Re: FortisBC Inc. (FBC)

Project No. 3698896

2016 Long Term Electric Resource Plan (LTERP) and Long Term Demand Side Management Plan (LT DSM Plan)

Response to the British Columbia Utilities Commission (BCUC or the Commission) Information Request (IR) No. 2

Figure 1: Net Load Forecast LTERP vs. Adjusted with Before-Savings Annual UPC Decreased by 0.5 Percent

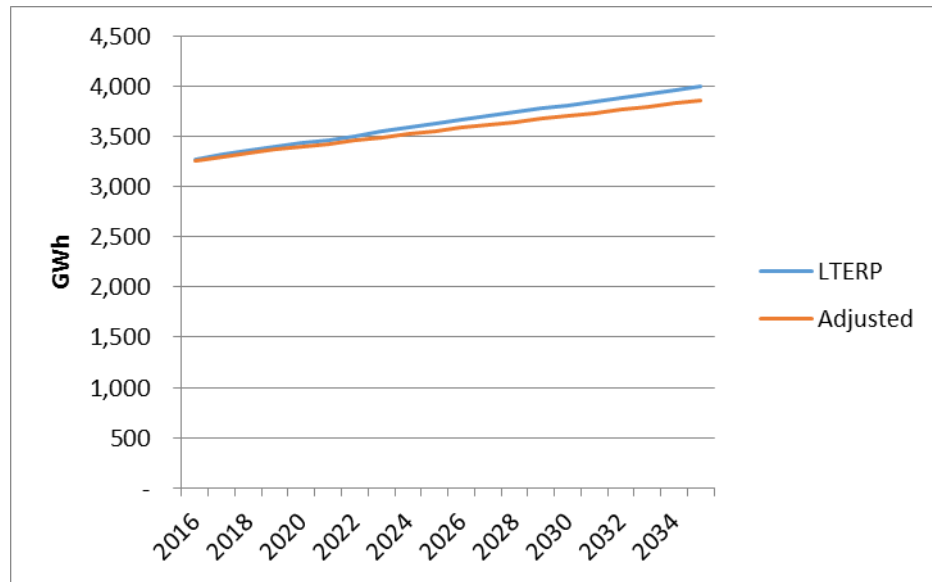
56.5 Please calculate the impact to the (i) residential forecast, (ii) total gross load forecast, and (iii) total net load forecast (presented in Appendix F of the Application) of using a forecast normalized before-savings pre-DSM residential UPC that declines at 0.5% per year for each year of the 20-year planning period. Please provide the necessary tables and charts with your response.

As shown in the table and figure above, a compounding 0.5 percent decrease in the residential UPC results in a residential load estimate that is more than 9 percent lower by 2035 than the forecast as filed. In terms of overall net load, the impact is 3.7 percent.

Figure 1: Net Load Forecast LTERP vs. Adjusted with Before-Savings Annual UPC Increased by 0.5 Percent

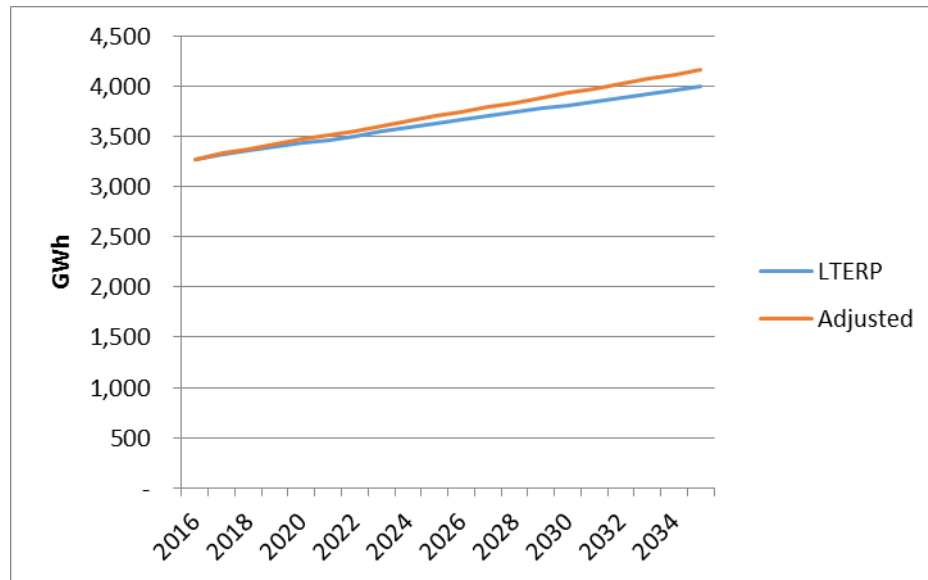
56.6 Please calculate the impact to the (i) residential forecast, (ii) total gross load forecast, and (iii) total net load forecast (presented in Appendix F of the Application) of using a forecast normalized before-savings pre-DSM residential UPC that increases at 0.5% per year for each year of the 20-year planning period. Please provide the necessary tables and charts with your response.

As shown in the table and figure above, a compounding 0.5 percent increase in the residential UPC results in a residential load estimate that is more than 10 percent higher by 2035 than the forecast as filed. In terms of overall net load, the impact is 4 percent.

Figure 1: Net LTERP Load Compared to Net Load with City of Penticton Load Decreased by Six Percent

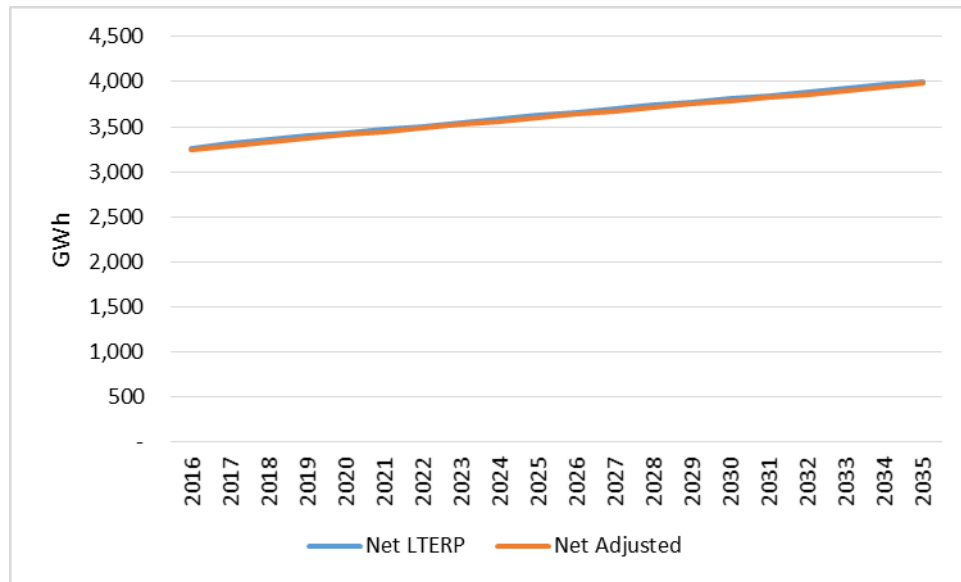
57.1 Please calculate the impact to the (i) wholesale load forecast, (ii) total gross load forecast, and (iii) total net load forecast (presented in Appendix F of the Application) if the Penticton load forecast for each year in the planning period was 6 percent less than forecast in the Application. Please provide the necessary tables and charts with your response.

A decline of 6 percent in the Penticton load results in a 3.6 percent decline in the total wholesale load and a 0.6 percent decline in the net load in 2035.

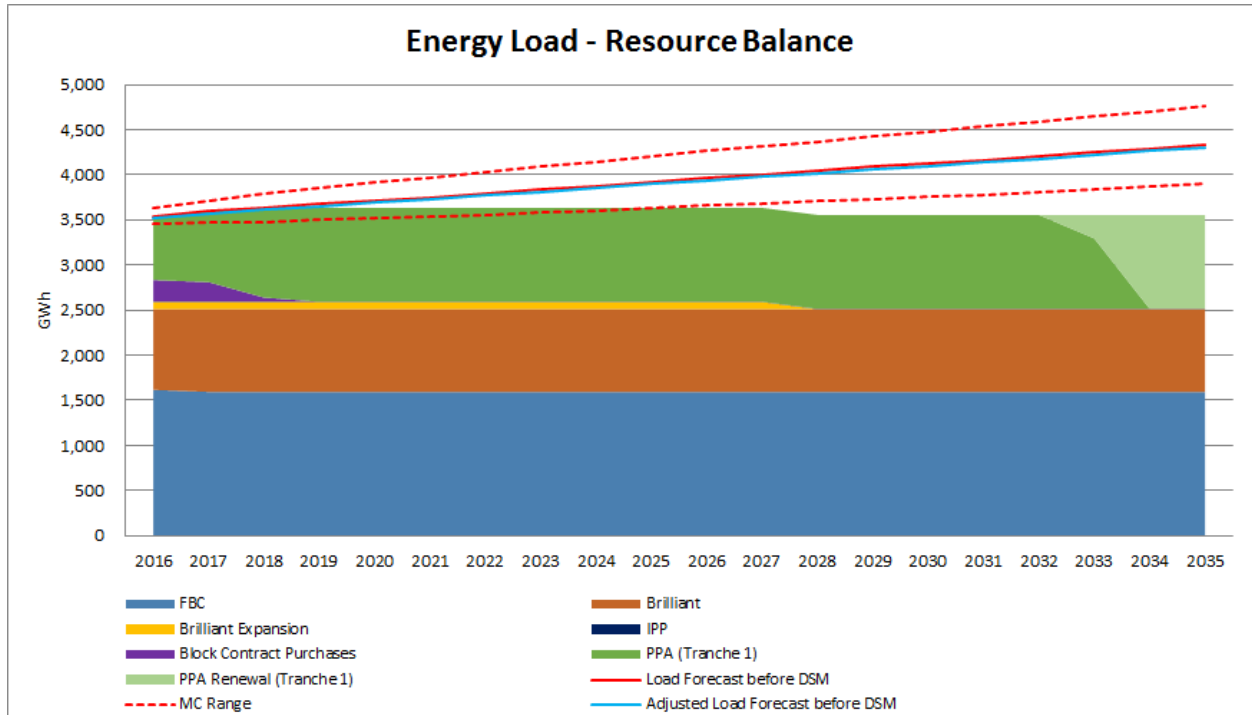
57.1.1 Please discuss, and provide updates where necessary, whether this would impact the FBC's load-resource balance as seen in figure 7-1 in the Application.

The impacts discussed in the response to BCUC IR 2.57.1 would not have a material impact on FBC's LRB as seen in Figure 7-1 of the LTERP. An updated version of this figure is provided below showing the adjusted load forecast in light blue.

- 1
- 2 The impact is immaterial because the impact of the 6 percent lower load forecast for Penticton
- 3 results in a less than 1 percent impact on the overall net load forecast.
- 4

Figure 1

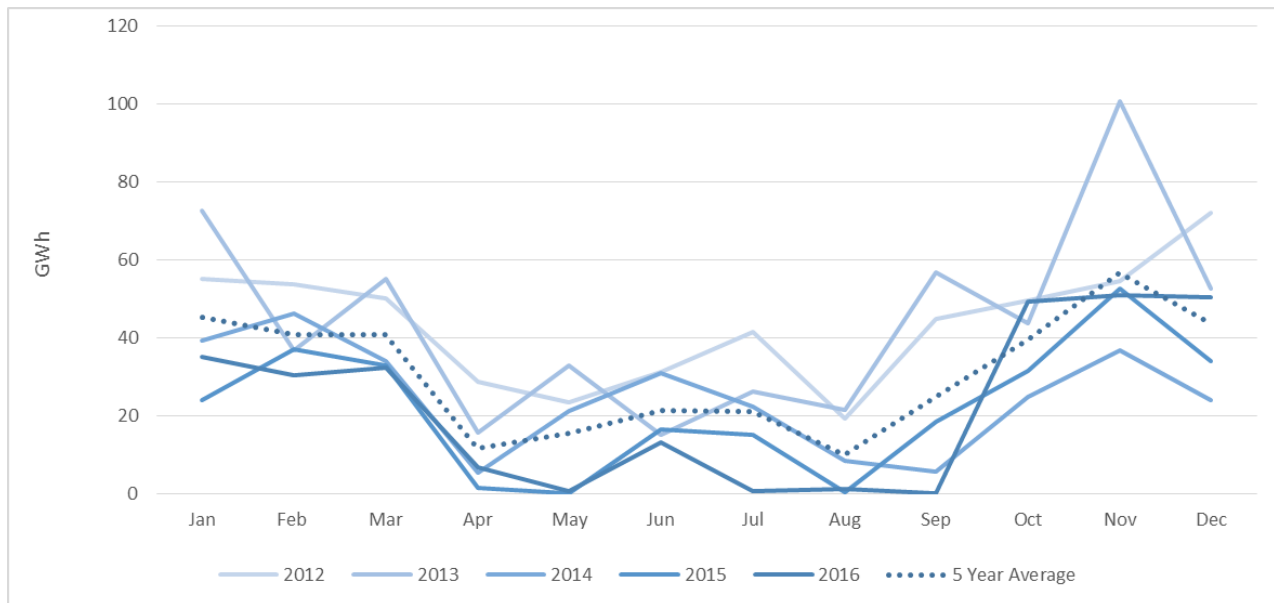
9 FBC states in BCUC IR 18.2 “The market price forecast presented in Figure 2-9 of the
10 LTERP does not include the risk of market price spikes since it presents average prices
11 on an annual basis.” FBC provides the average unit cost for FBC’s market energy
12 purchases from 2012 to 2016 in Shadrack 10 (ii):

19 Please refer to Table 1 and Figure 1 below, which show FBC’s market purchase volumes by
20 month delivered during each year from 2012 to 2016 as well as a five year monthly average.
